Groundwater Application Review Summary Form

Application # G- 18994

PUBLIC INTEREST REVIEW FOR GROUNDWATER APPLICATIONS

TO: Water Rights Section Date 8/9/2023
 FROM: Groundwater Section Grayson Fish
Reviewer's Name
 SUBJECT: Application G- 18994 Supersedes review of 9/17/2020
Date of Review(s)

D1. Well #: 1 Logid: KLAM0001501

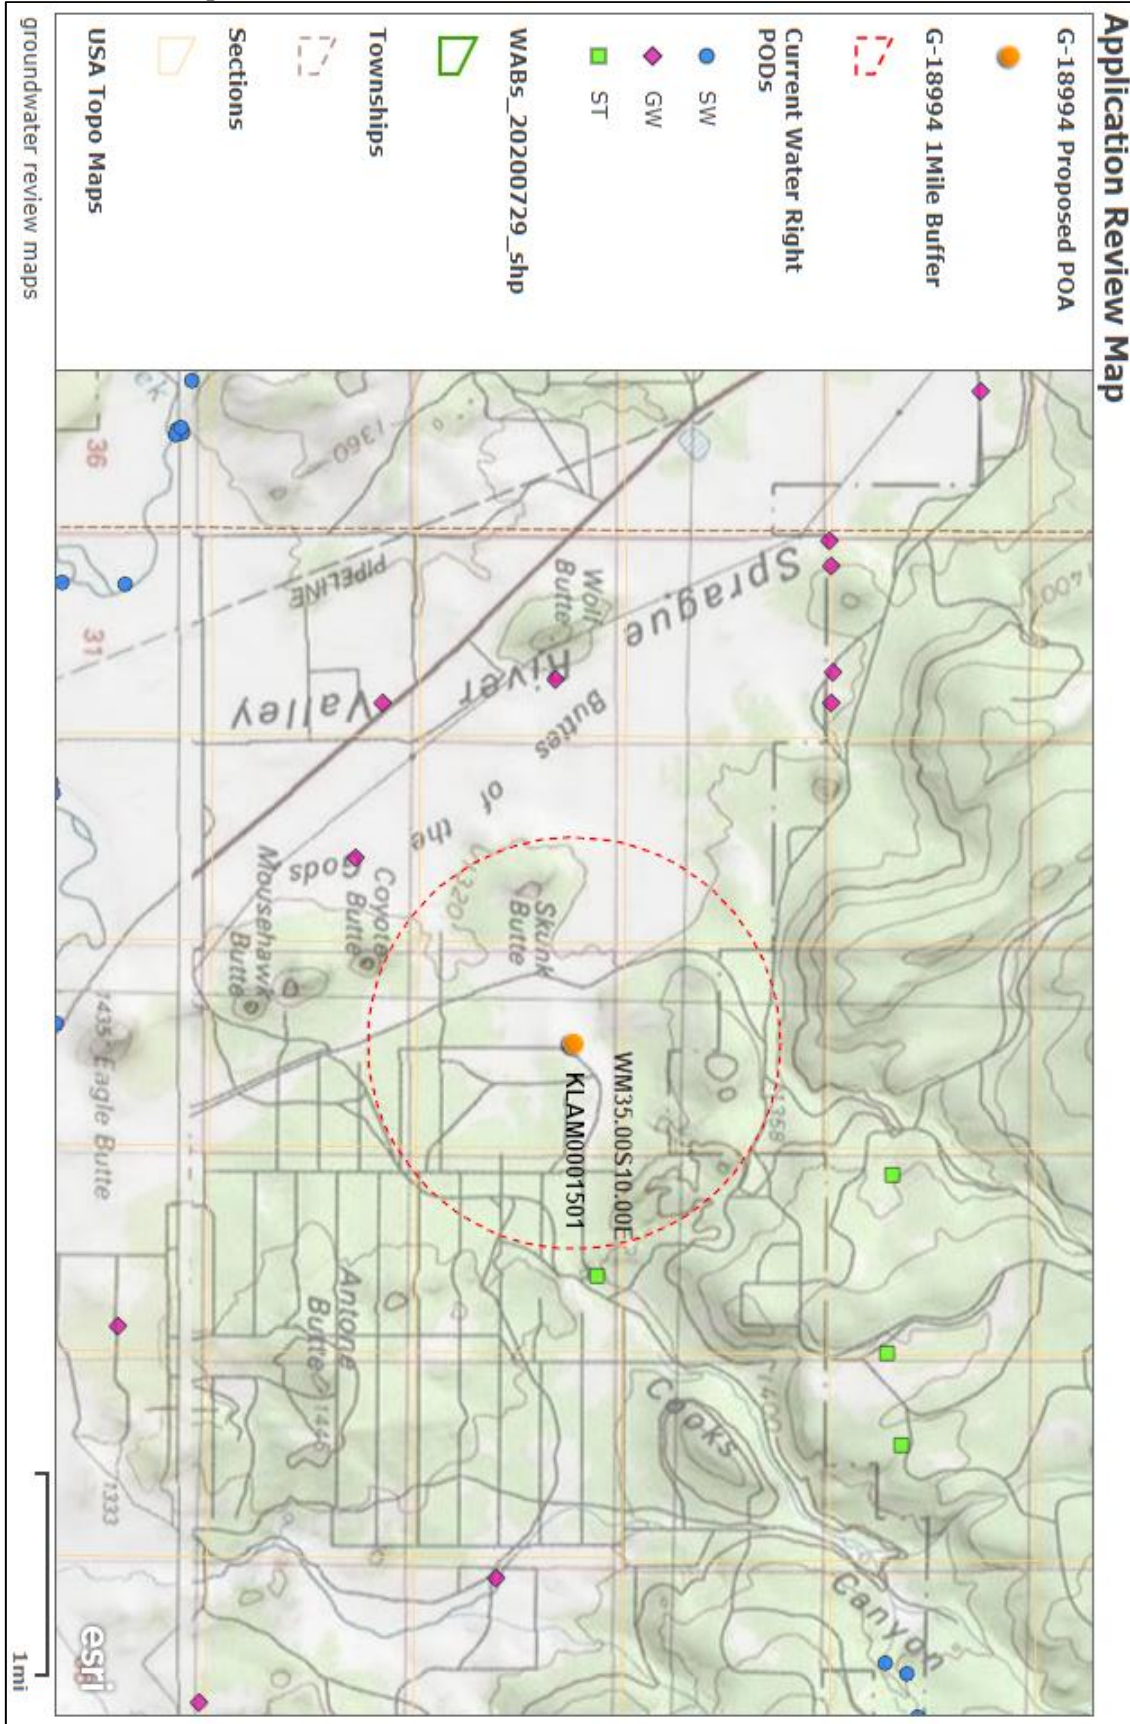
Seal depth appears to be insufficient to eliminate commingling between aquifers.

This finding has been retained from the initial 2020 review for the sake of consistence with established procedures of the time. Regardless, well construction should be reviewed by the Well Construction and Compliance Section.

D4. **Route to the Well Construction and Compliance Section for a review of existing well construction.**

Water-Level Measurements in Nearby Wells

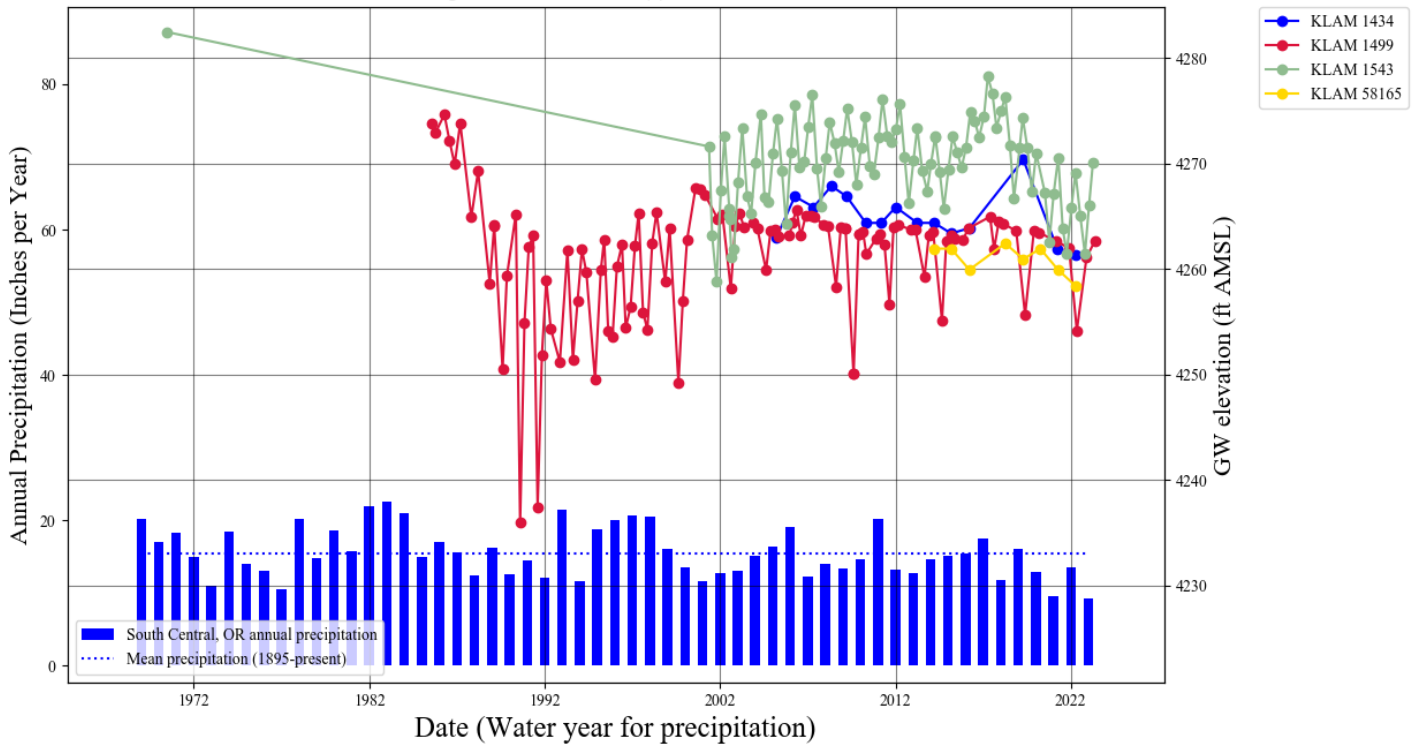
Groundwater levels observed in nearby wells KLAM 1434, KLAM 1499, KLAM 1543 and KLAM 58165 do show evidence of declines. For example, KLAM 1499 indicates that groundwater levels in that well have declined approximately 12 feet between the 1980's and present day. KLAM 1543 shows a declining trend which appears to follow precipitation trends starting after 2017 and beginning to level off in 2023 with 8 feet of decline observed over that period. However, available groundwater level data in the noted wells do not display excessive declines or excessively declining trends, therefore there is not a preponderance of evidence that groundwater of the target aquifer is over appropriated. Similarly, there is not a

preponderance of evidence that the proposed use would not be within the capacity of the resource and so conditions in B1(d) are recommended.

Stream-depletion Modeling Results

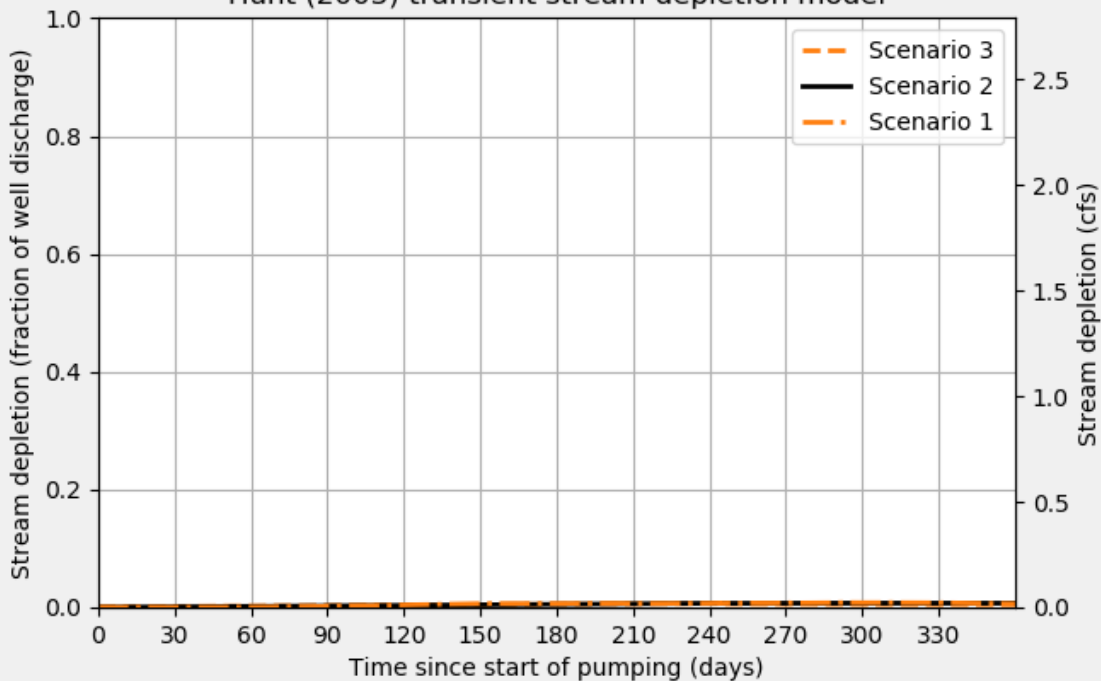
Comments: Stream-depletion was estimated using the Hunt-2003 analytical model and parameter values taken from the OWRD Pump Test database, published reports, or values in the expected range for the given material. Given the large distance between the proposed POA and the stream, along with the thickness of the overlying confining layer, low values of stream-depletion is expected.
